CONVAIR

COMMERCIAL CHANGE PROPOSAL

SPEC NO.: ZD- 22-002

MODEL: (880) 22-1

Enclosure: (A) One copy of sketch - GASEOUS OXYGEN SYSTEM
(for preliminary use only, Figure 3.19-4 will
be revised to reflect the above change)

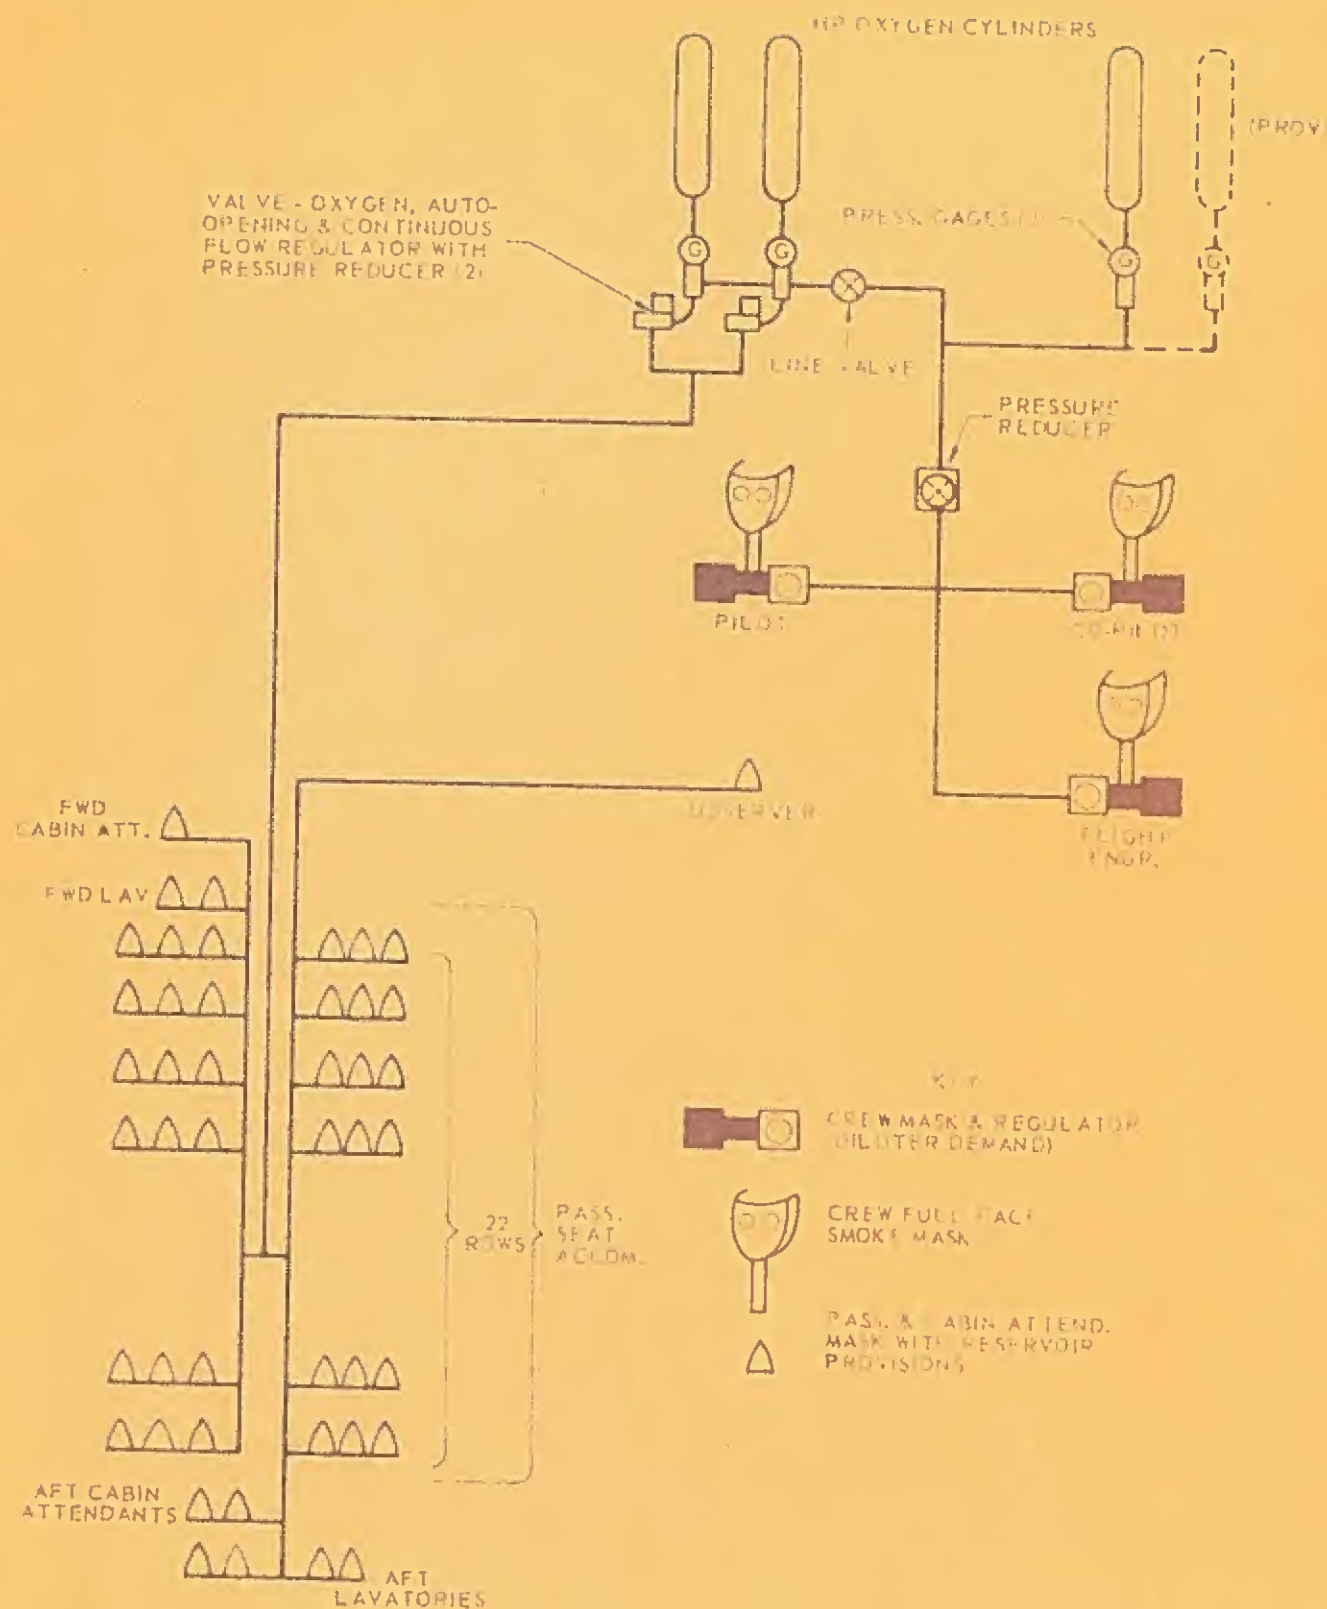
Page 118, Paragraph 3.19.5.4 INDIVIDUAL OUTLETS:

Change the third sentence to read as follows:

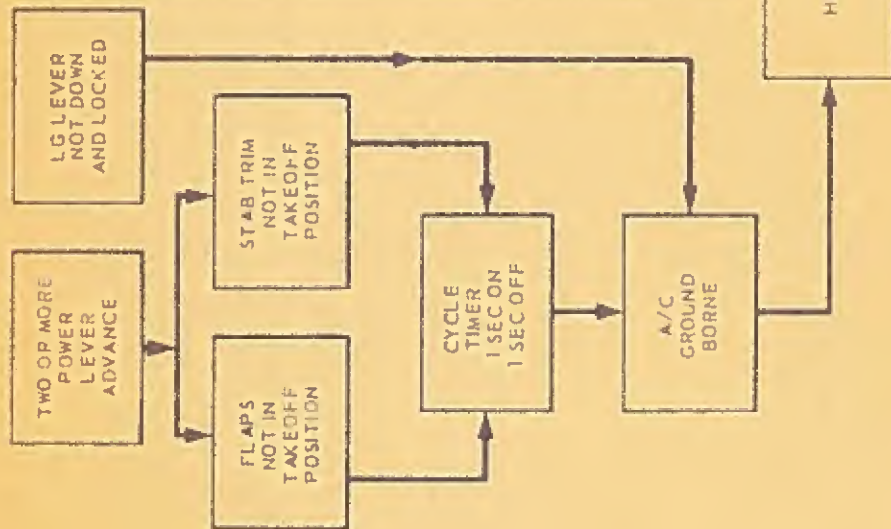
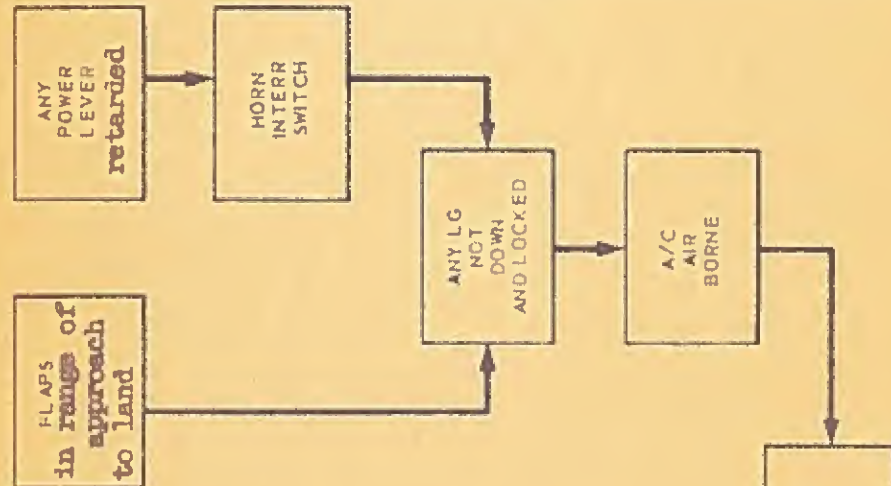
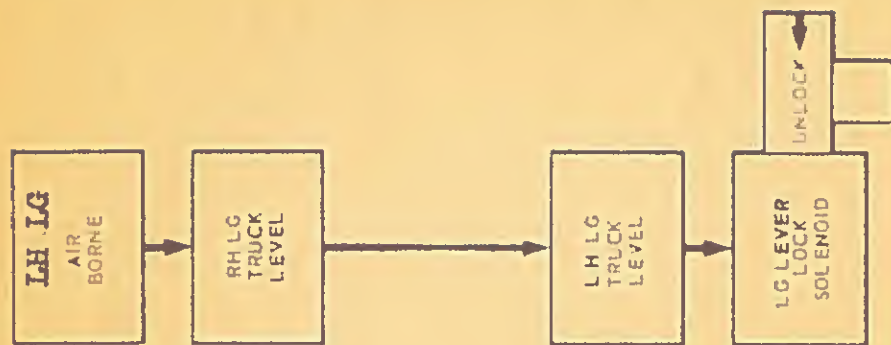
Revise the paragraph title and paragraph to read as follows:

"LANDING GEAR AND STABILIZER WARNING HORN: A horn shall be provided to operate under the following conditions:

When any landing gear is not fully extended and locked with the aircraft airborne, the horn will operate if any power lever is retarded or if the flaps are in the range of approach to land. The power lever retard function will have a horn interrupter switch.

When the aircraft is ground borne, the horn will operate if the landing gear override lever is moved.

When the airplane is on the ground and any two or more of the power levers are advanced to take-off position, the horn will operate if the stabilizer and/or the flaps are not in the correct takeoff position.

C.G. & M.A.C.
C.G. DESIGN LIMITS

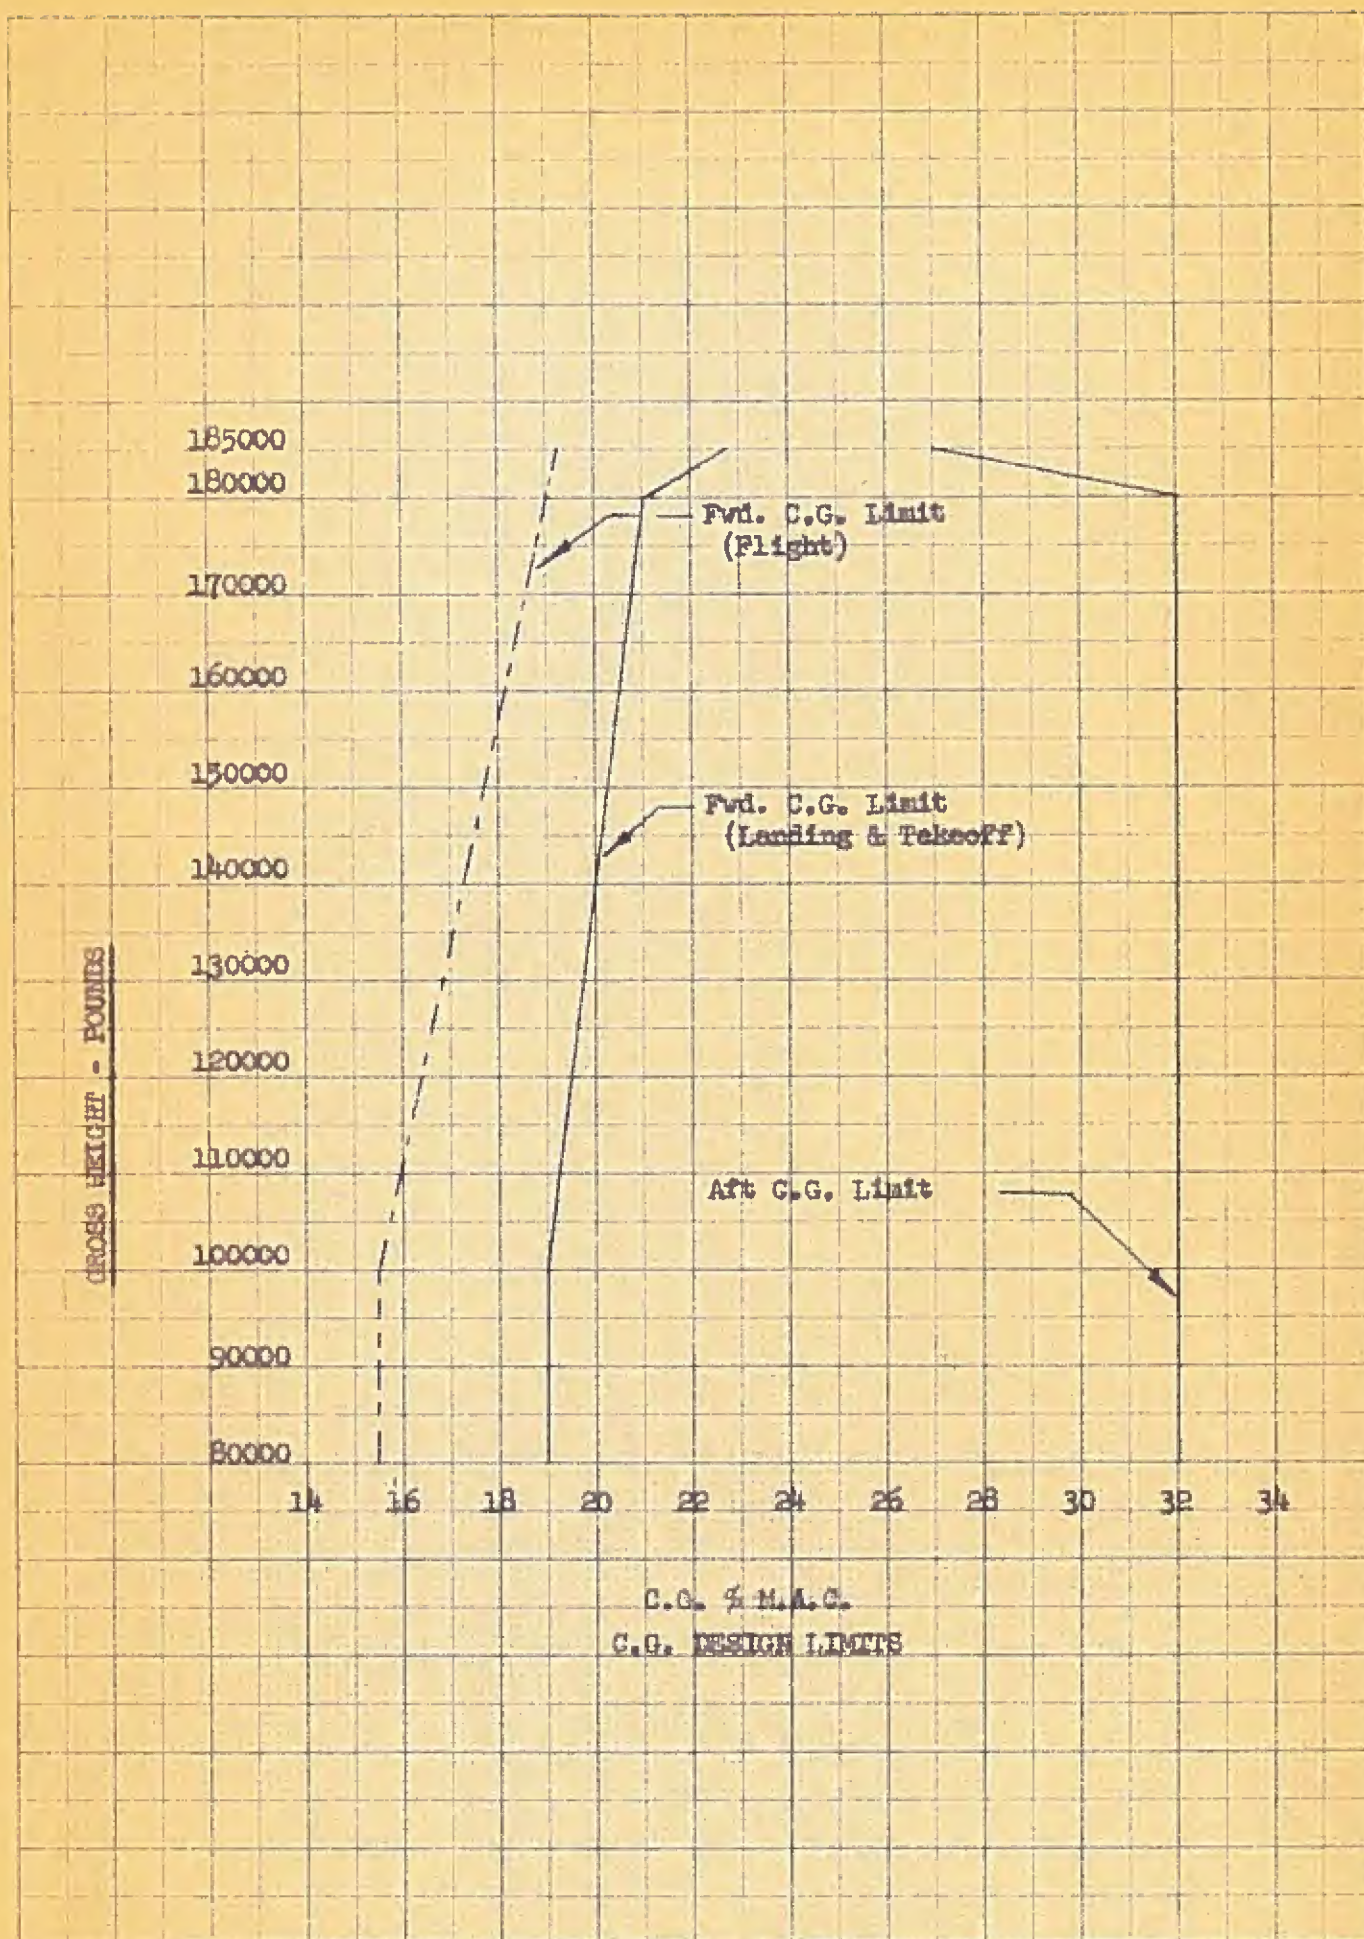
"Weight increase of 84 lbs is based on C. G. limits shown on Enclosure (A). If the airplane is operated at gross weight above 180,000 lbs, with center of gravity location outside of the indicated limits, heavier tires and main landing gear will be required."
